Re: Chevron Service Station # 9-0917

Address: 5280 Hopyard Road, Pleasanton, California

Re: **Response to Comments**
Chevron Service Station 9-0917
5280 Hopyard Road, Pleasanton, California
Fuel Leak Case No. RO0000439

Site Plan with Dissolved and Residual Hydrocarbon Impact

Figure: 1 – Site Plan with Dissolved and Residual Hydrocarbon Impact

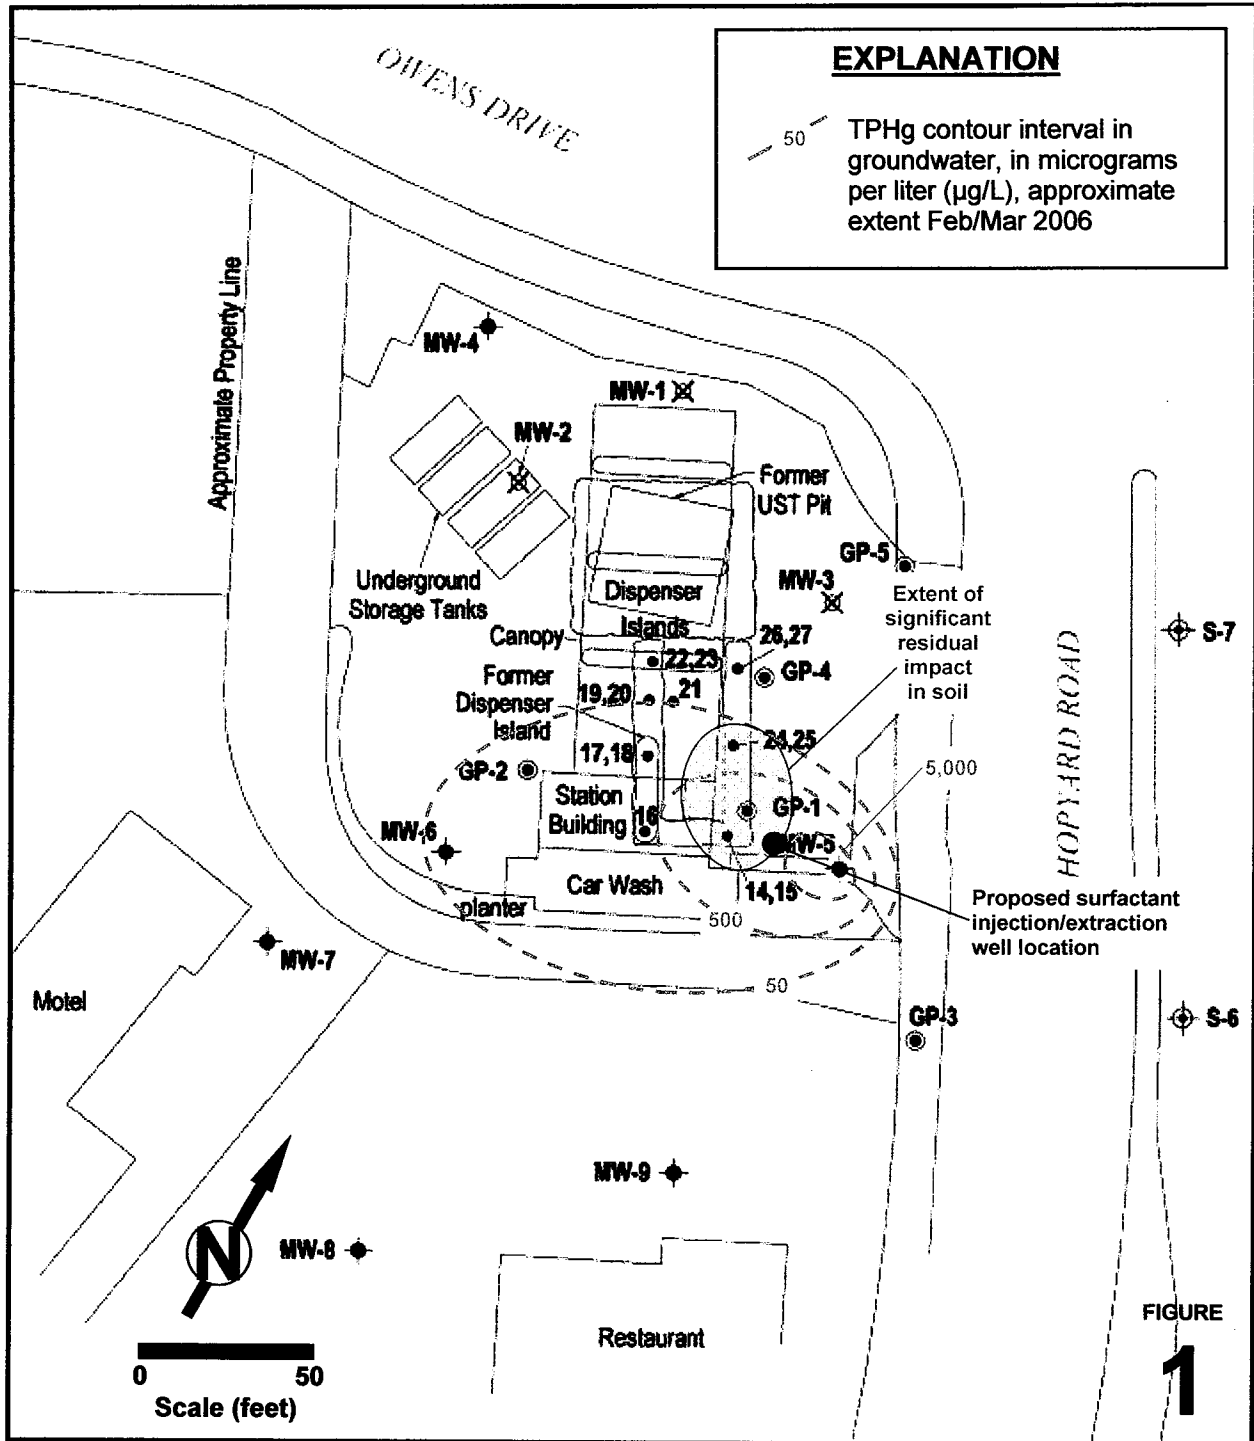
1) Will the proposed remedial action be expanded to treat the source area, and is it feasible to treat the source area with the proposed technology given the current site configuration?

2) Discuss how the radius of influence will be determined around well MW-5, or whether an additional monitoring or extraction well will be needed to conduct the pilot test.

1. **Scope of Pilot Test.** Surfactant is to be applied at a rate that will reach a radius of approximately 10 feet from the well prior to vacuum-enhanced recovery. Well MW-5 is located approximately 25 to more than 100 feet from the sampling locations where elevated concentrations of petroleum hydrocarbons were detected in soil during the 1991 UST, dispenser, and piping replacement. Therefore, the pilot test will only treat soil and groundwater within a limited radius of well MW-5 and will not treat soil and groundwater within most of the source area. Although we do not object to the use of surfactant enhanced extraction in a pilot test, please describe in the requested Response to Comments whether the pilot test would be expanded to treat the remainder of the source area and the feasibility of treating the source area given the current configuration of the service station.

2. **Monitoring Performance of Pilot Test.** Performance during the pilot test will be estimated using groundwater concentrations in samples collected monthly from injection/extraction well MW-5. Therefore, the distance away from the well over which the treatment is effective will not be known. Please describe in the Response to Comments requested below, how monthly concentrations in well MW-5 can be used to estimate the distance from the well that the surfactant treatment is effective or propose an additional monitoring or extraction well to conduct the pilot test.

Cambria will expand the proposed remedial action as warranted by the results of the pilot test to treat the source area as described below. As shown on Figure 1 and discussed below, the majority of residual hydrocarbon impact appears to be limited in extent near the north-northeast corner and northeast side of the existing station building, and implementation of the proposed surfactant remedial alternative should be feasible for a majority of this area.

In order to better evaluate the radius of remedial influence, and target more known residual impact in soil, Cambria will install a surfactant injection/extraction well for the pilot test at the location shown on Figure 1, near boring GP-1. This location places the remedial well within the area identified as having the majority of residual impact in soil at the site—in the area of the former easternmost product lines. Although the highest residual hydrocarbon concentration in

Cambria proposes the following scope of work to install one injection/extraction well at the location shown on Figure 1.
